Fletcher Allen Health Care
Inpatient Building Project
City of Burlington
Sketch Plan Application - Plans

DESIGN ADVISORY BOARD Tuesday, March 25, 2014 Conference Room 12, City Hall, Burlington, VT AGENDA

TO: Design Advisory Board
FROM: Scott Gustin
DATE: February 25, 2014
RE: 14-0038CA, 395 Manhattan Drive

SKETCH PLAN REVIEW
INPATIENT BUILDING PROJECT

NORTH FACE

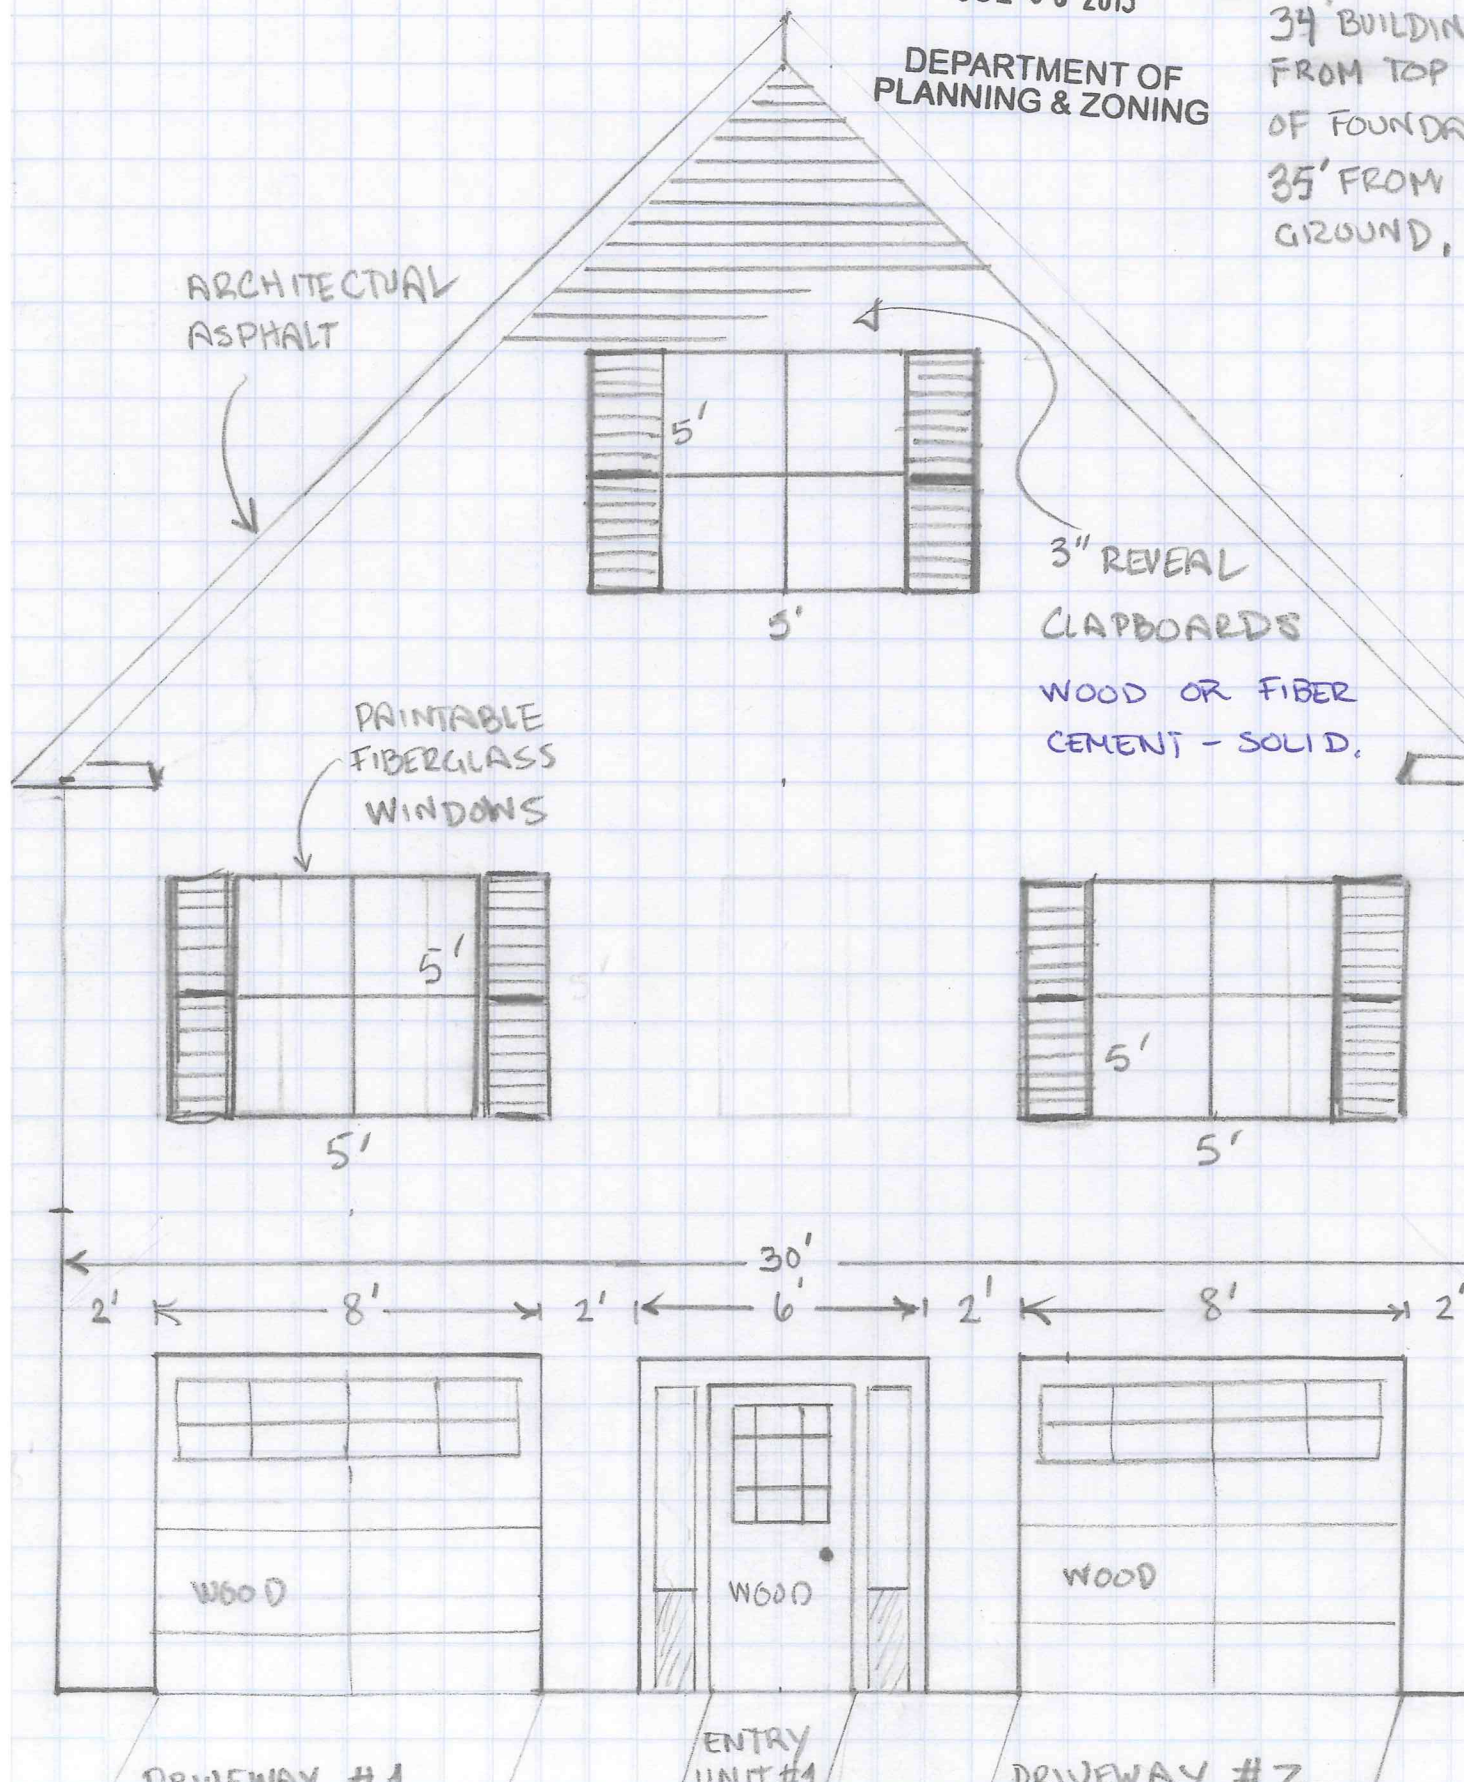
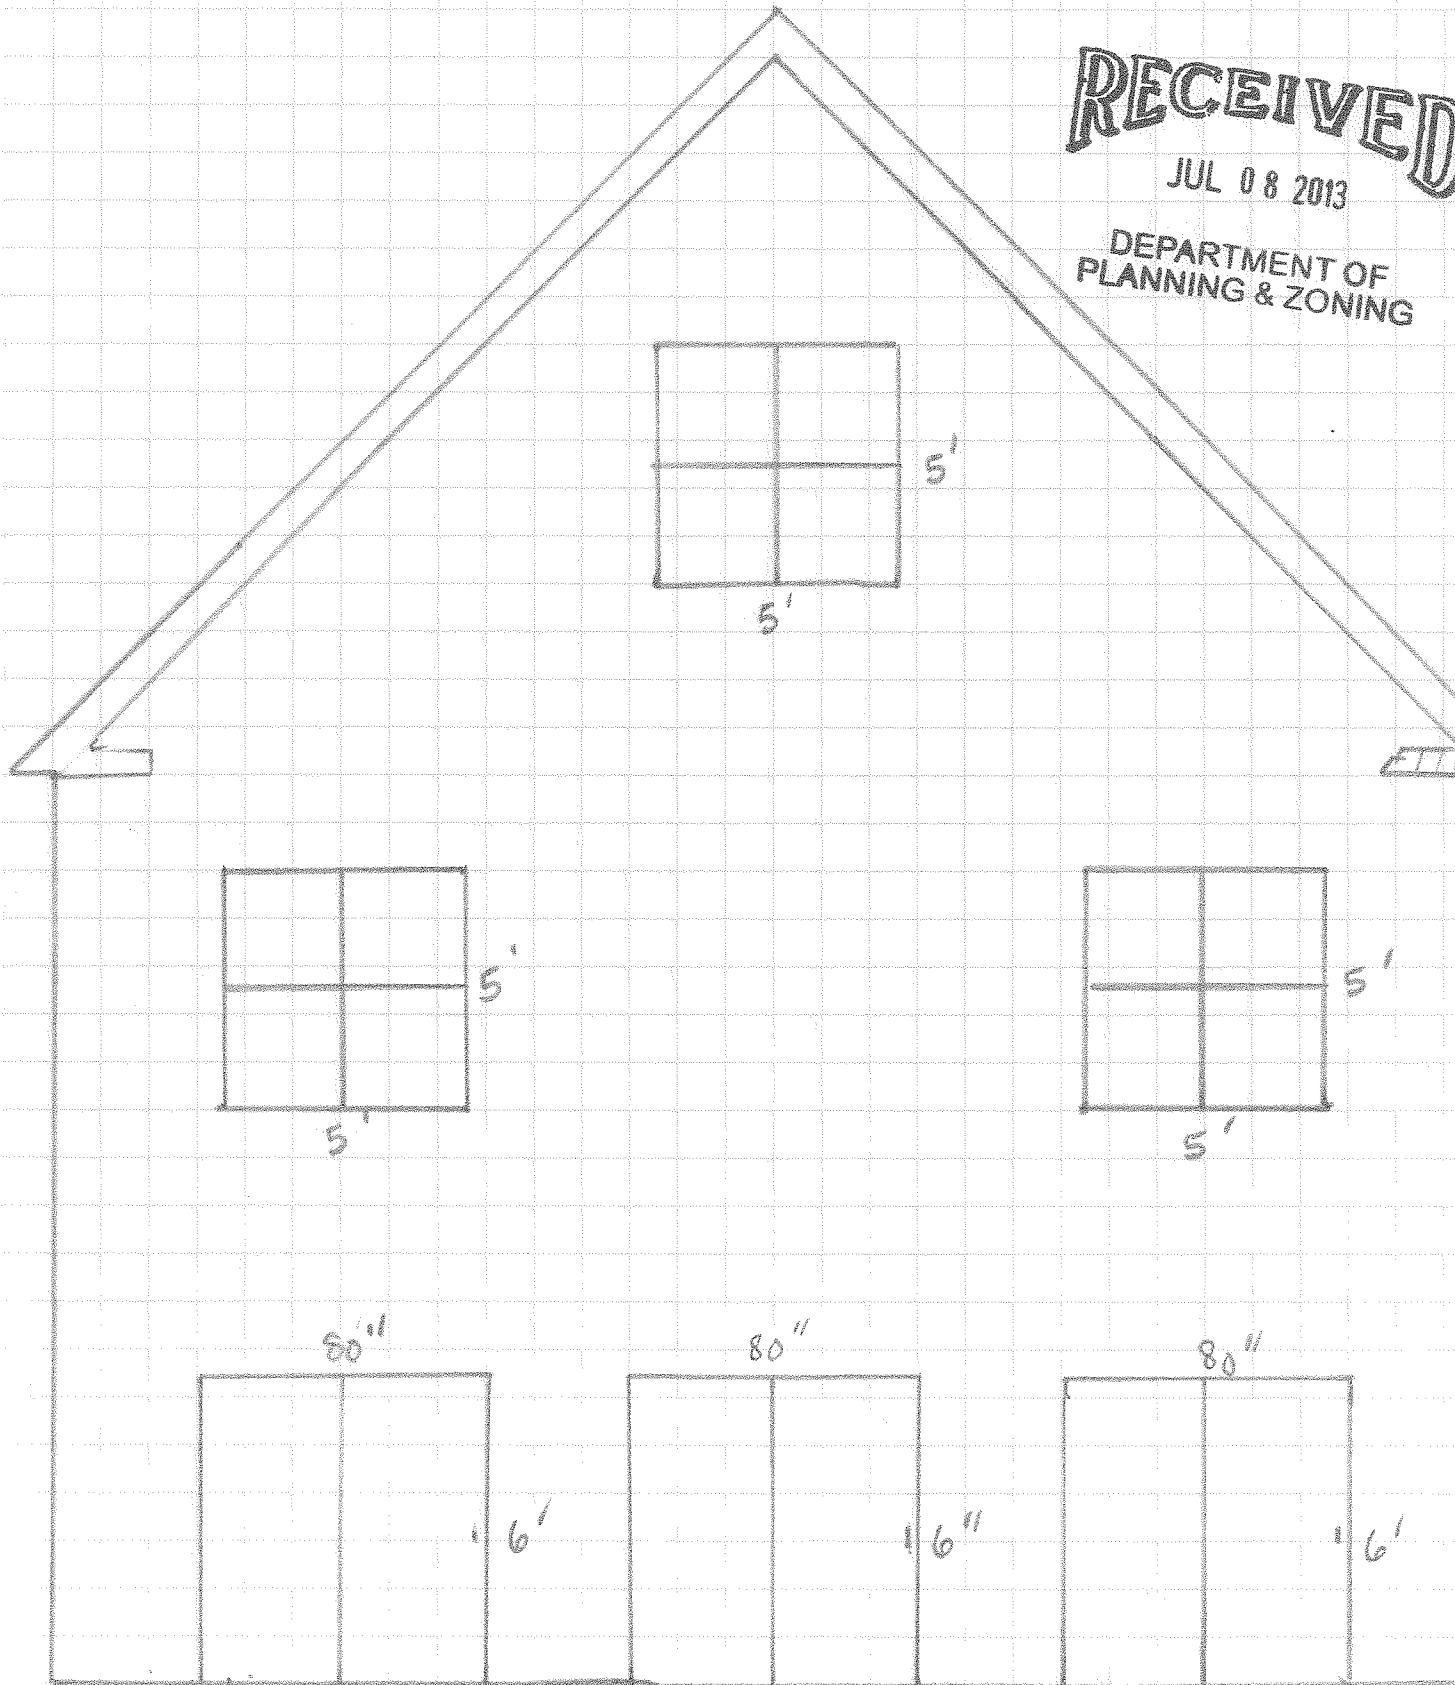
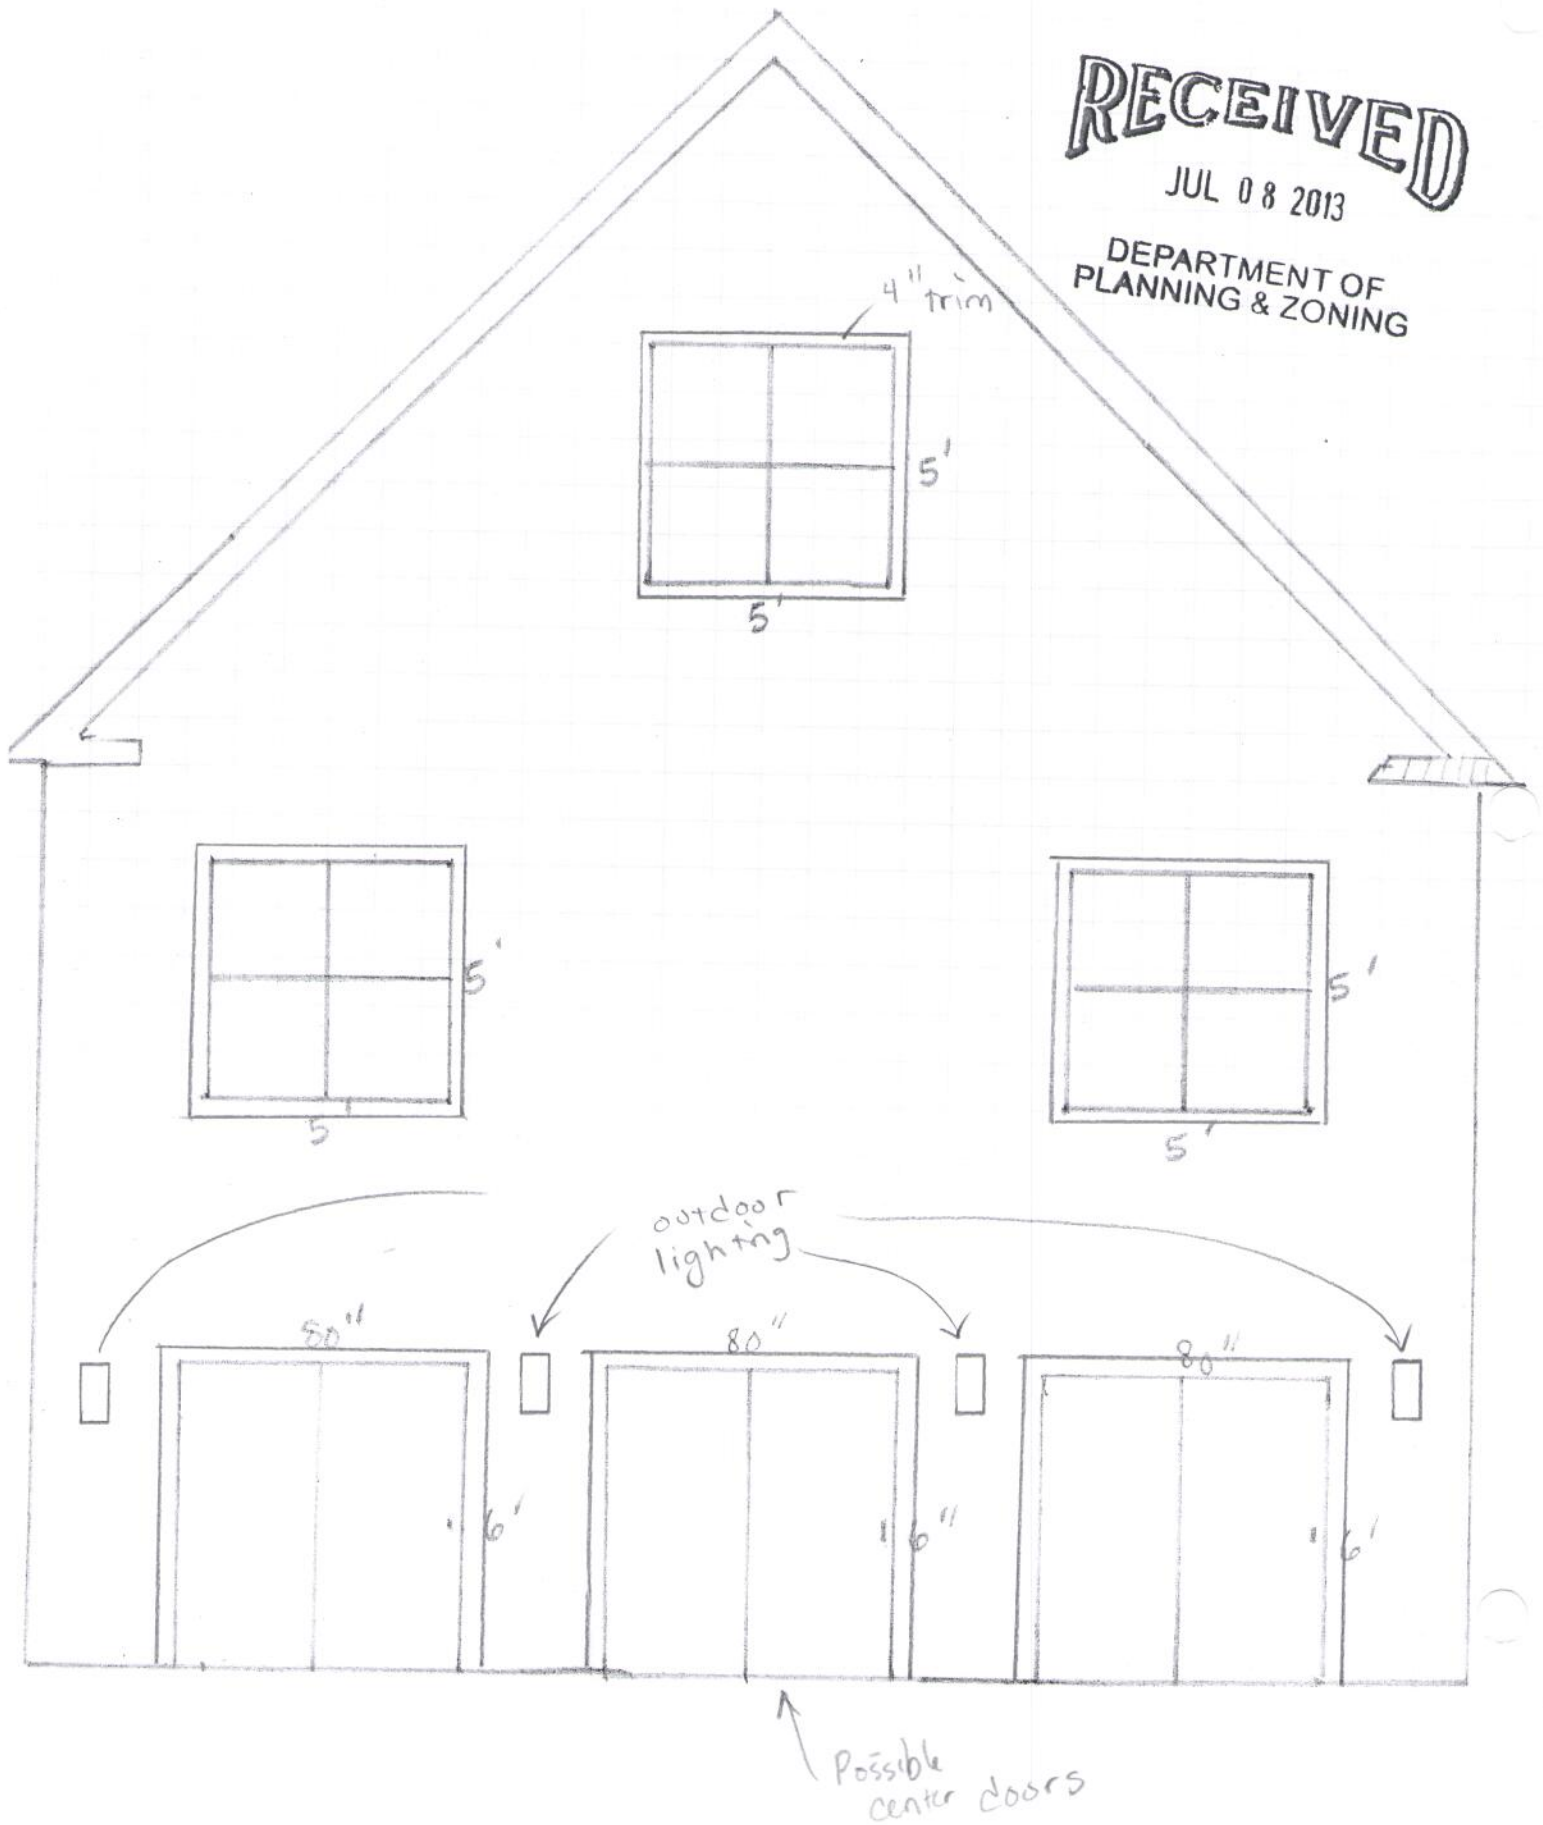
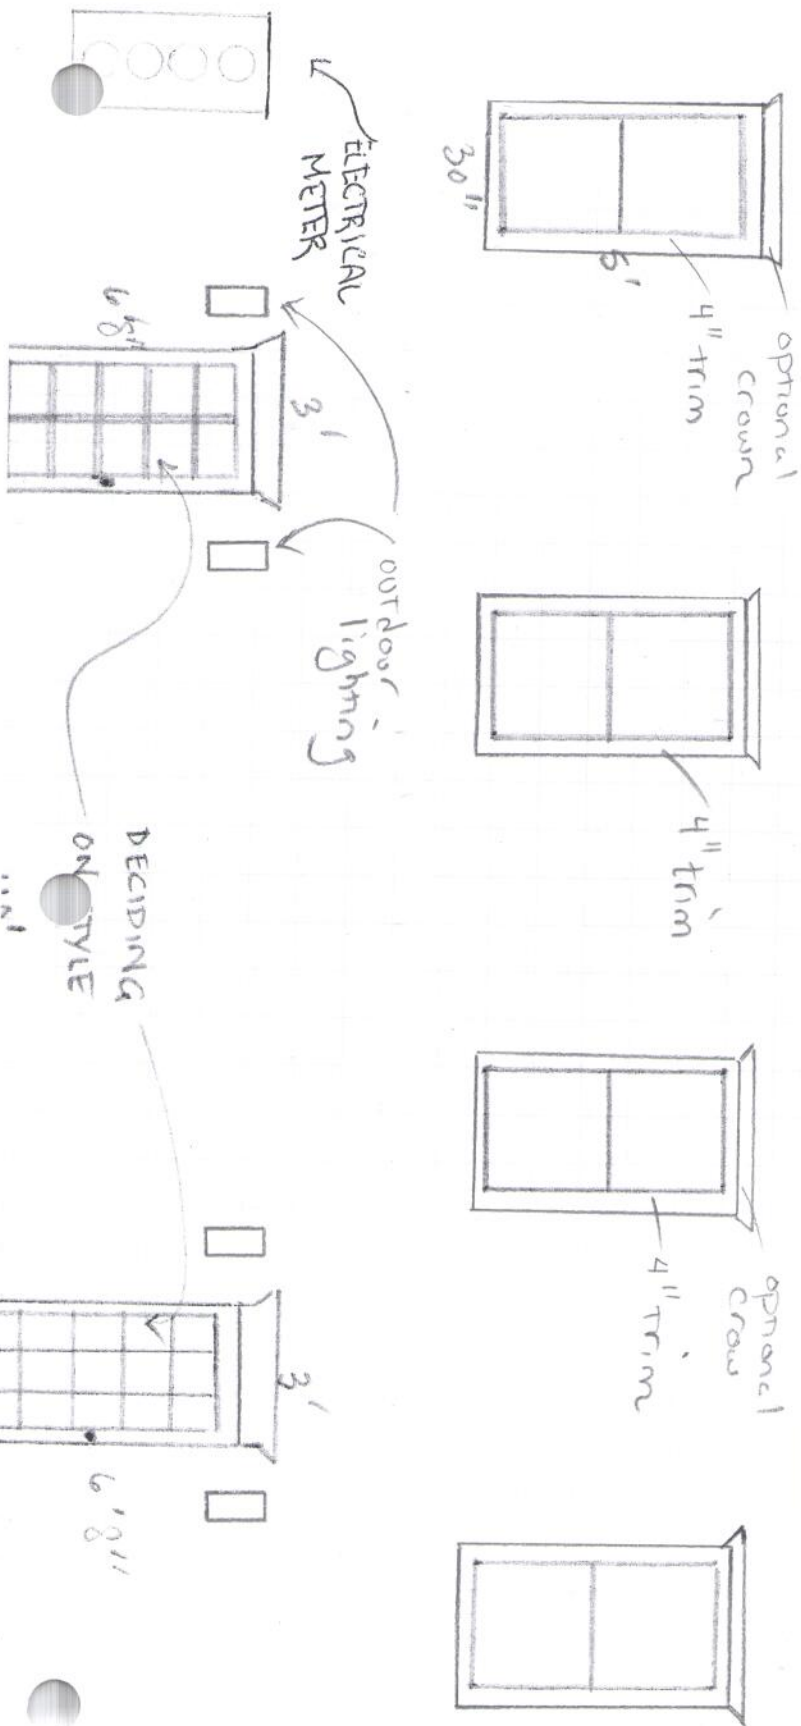
The front façade includes two garage entries. These entries are flush with the front face of the building and must be revised so that they are set behind the pedestrian entrance into the building. No specific setback distance for the garage doors is required; however, there must be a break in the building plane with the pedestrian entrance more prominent than the garage entries. A slightly projecting front entry may be the most appropriate option in light of the overall building design. The garage doors comprise some 53% of the total front façade width. This width is permissible so long as they are under a single roofline and wholly integrated into the overall building design and there is living space above them. Such is the case here.

Fenestration details provided are very limited. The newly provided window specification sheet continues to depict 1-over-1 double hung units whereas the elevation drawings suggest large 2-over-2 casement or awning units. Perhaps they are side-by-side double hung units. Clarification is needed. Trim and casing details are also lacking. Building entries are similarly lacking in detail. A front door is proposed, and what seem to be rear sliding doors are also proposed. Improved elevation drawings that depict all trim details are needed.

The proposed home is located close to the sidewalk as neighboring buildings are. Its front entrance is clearly discernible. As noted above, some variety should be incorporated into the front façade. The central pedestrian entry should project out, and variety should be incorporated into the building materials palate. As stated before, trim details are also needed.

Exterior building materials consist of wooden or fiber cement clapboards and fiberglass windows. Asphalt shingle roofing is proposed. Trim materials are not noted and must be.

1. A revised front entry that projects in front of the adjacent garage doors.
2. A landscaping plan that depicts generally what new plantings are proposed where. A rain garden is encouraged for receiving and infiltrating roof runoff.
3. Outdoor lighting fixture locations and cut sheets.
4. Windows depicted on the building elevations that match the windows in the cut sheets provided. Basement egress windows must be depicted in the elevation drawings. Elevation drawings must show details accurately.
5. Trim materials noted on the elevation drawings.
6. Incorporate of some variation in cladding on the front façade to differentiate the upper floor from the bottom two floors (i.e. shingles vs. clapboards).
